CERTIFICATE OF APPROPRIATENESS

Property: 540 Columbia Street, Lot 22, Block 286, Houston Heights Subdivision. The property includes a historic 1,840 square foot, one-story wood frame single-family residence and a detached garage situated on a 6,600 square foot (50' x 132') interior lot.

Proposal: Alteration/Relocation – Resubmittal: At the November HAHC meeting, the applicant was denied an application to move the house 8' closer to the north property line, from current 10'-9" setback to 3'. Construct a 1,553 square foot addition and attached garage behind and on top of the rear 27.5% of the 1,840 square foot residence. The project also included the following alterations:

Recommendation: Denial - does not satisfy criteria

NORTH SIDE ELEVATION

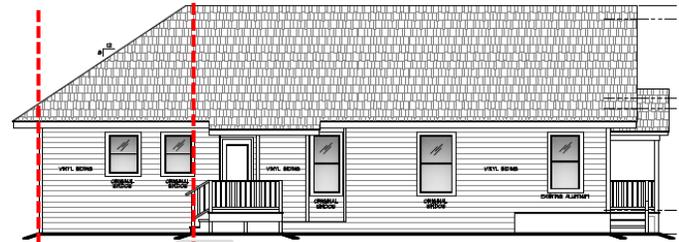
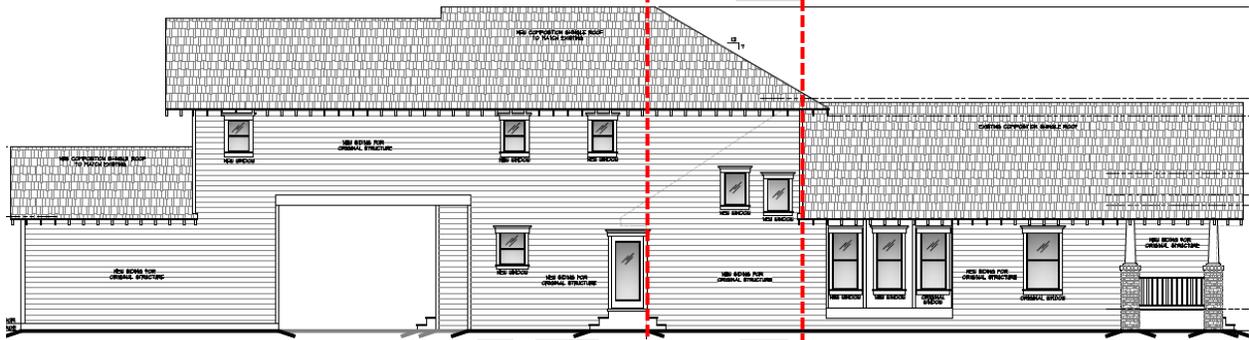
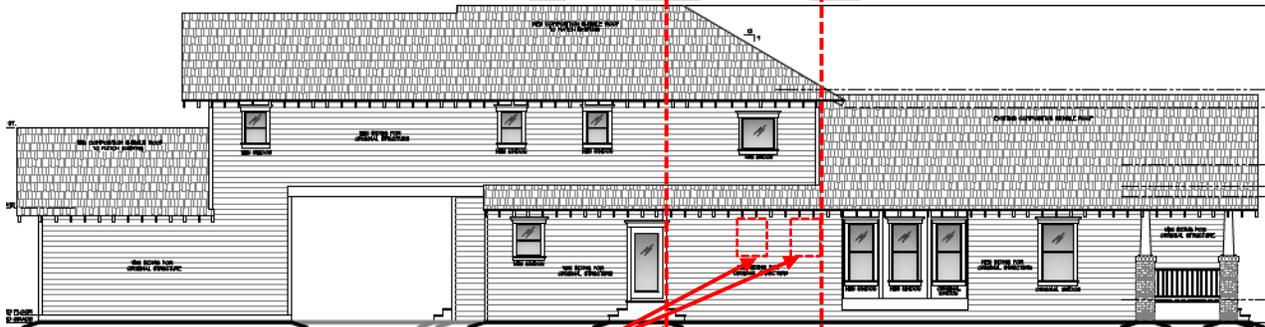
ORIGINAL WINDOWS TO BE REMOVED

START OF ADDITION

ORIGINAL REAR WALL

SOUTH SIDE ELEVATION

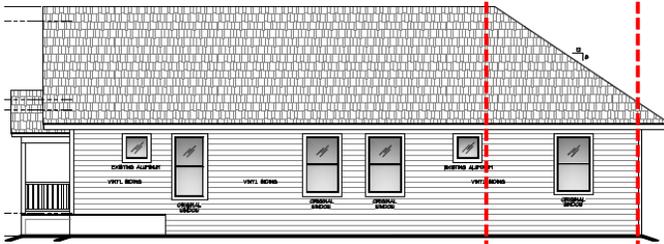
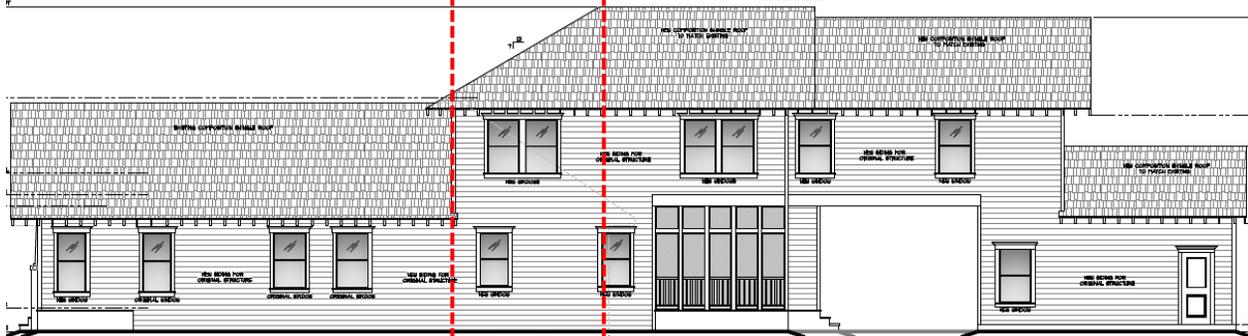
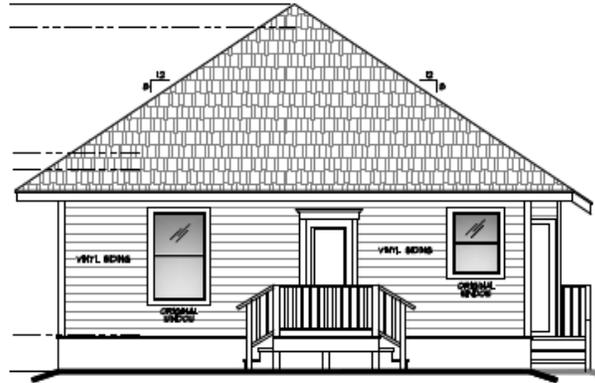
START OF ADDITION

ORIGINAL WINDOW TO BE REMOVED

NEW WINDOW OPENINGS

ORIGINAL REAR WALL

WEST (FRONT) WALL

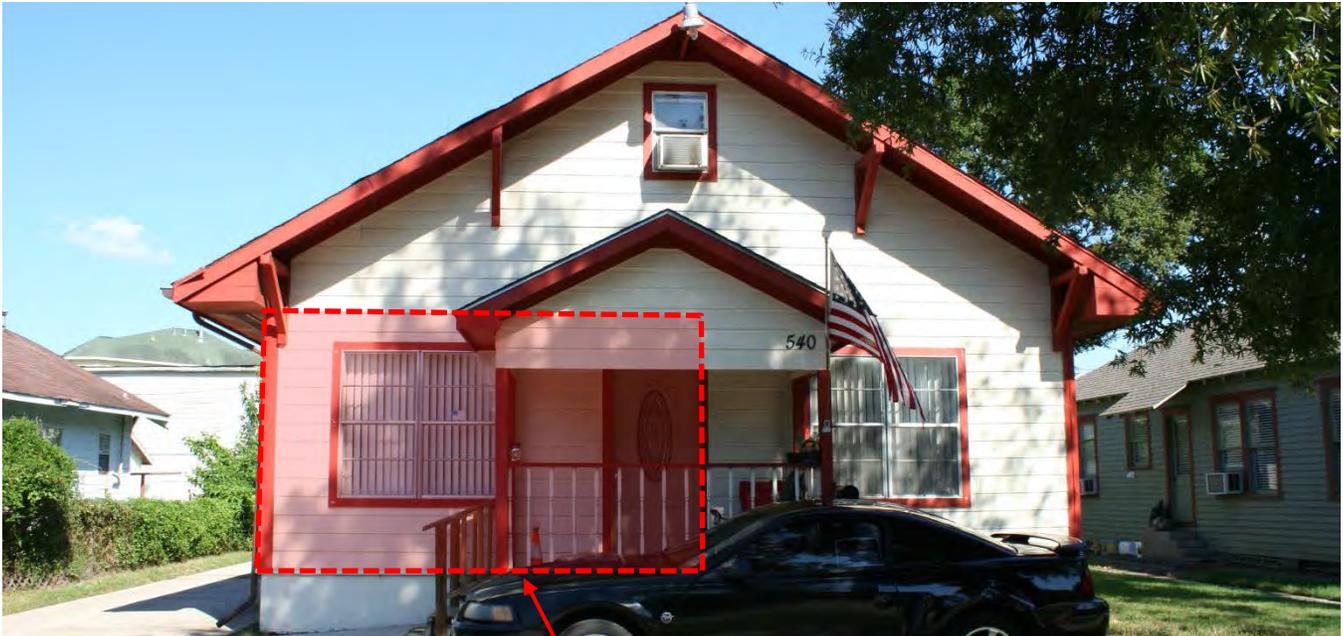
*NON-ORIGINAL ALUMINUM WINDOWS, DOOR AND STOOP
TO BE REMOVED*

LOCATION OF ENCLOSED INSET PORCH TO BE RE-OPENED

NORTH WALL SIDING DETAILS

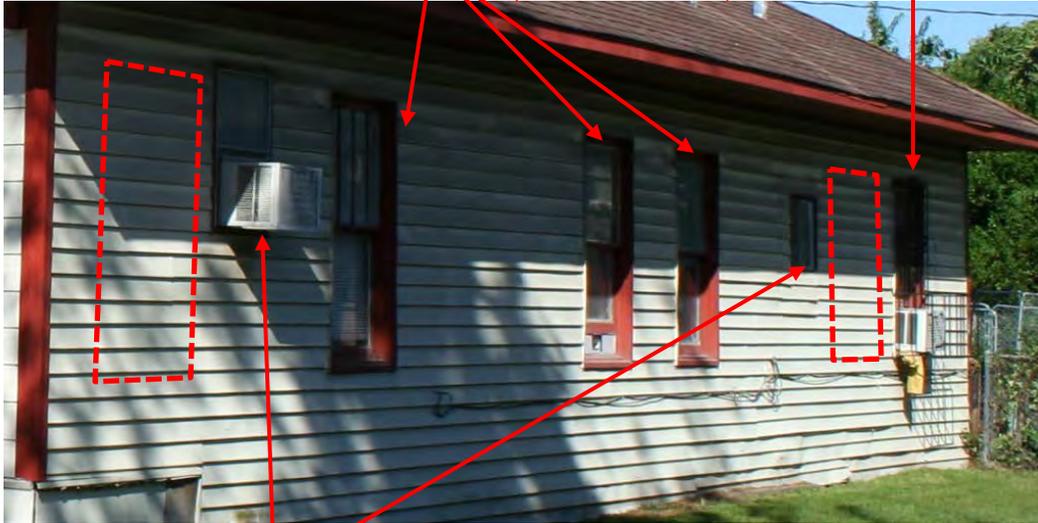
*ORIGINAL WINDOWS TO BE REMOVED
(SEE DETAIL BELOW)*

ALUMINUM WINDOW TO BE REMOVED

METAL DOOR AND A/C OPENING TO BE REPLACED WITH WOOD WINDOWS

ORIGINAL WINDOWS TO BE REMOVED

SOUTH WALL SIDING DETAILS

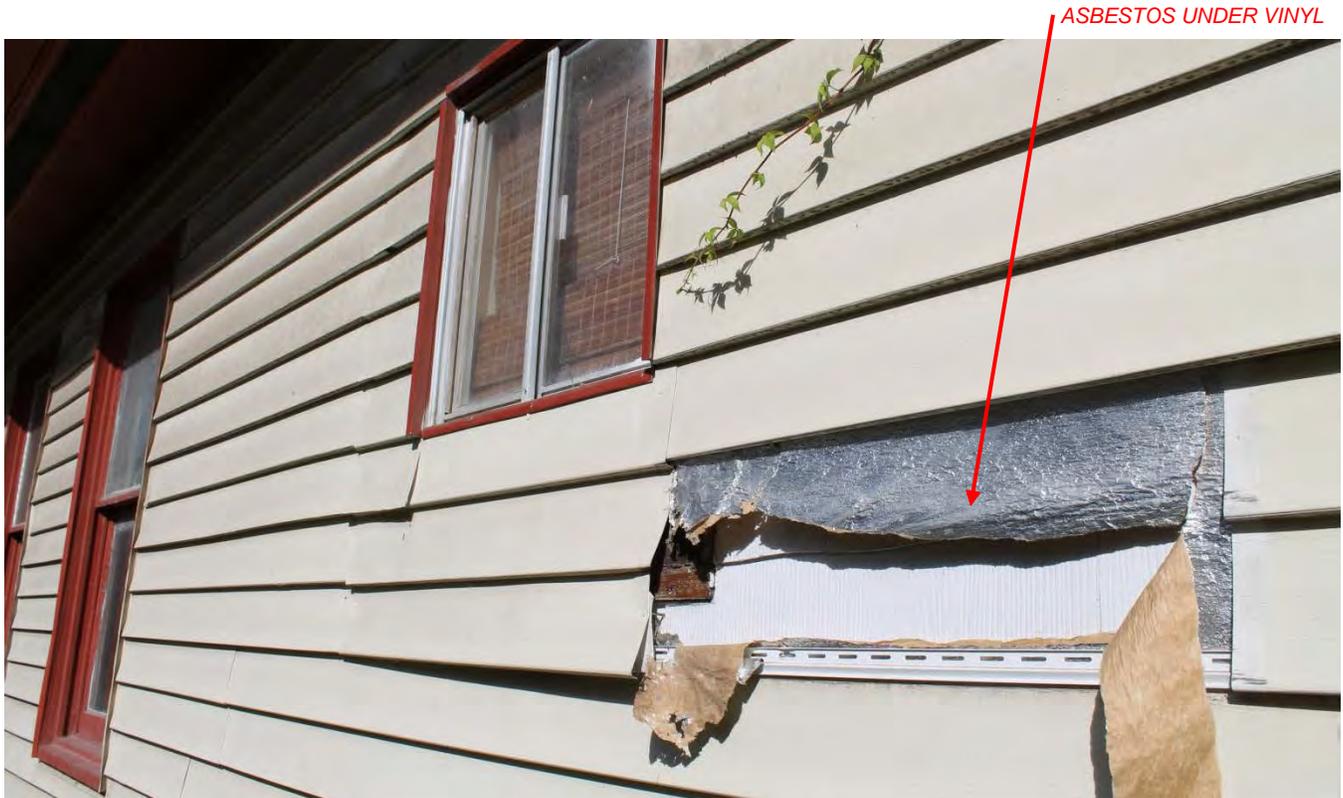
*ORIGINAL WINDOW TO BE REMOVED
(SEE DETAIL BELOW)*

ALUMINUM WINDOWS TO BE REMOVED

PROPOSED NEW WINDOW OPENINGS

ROT IN SILL
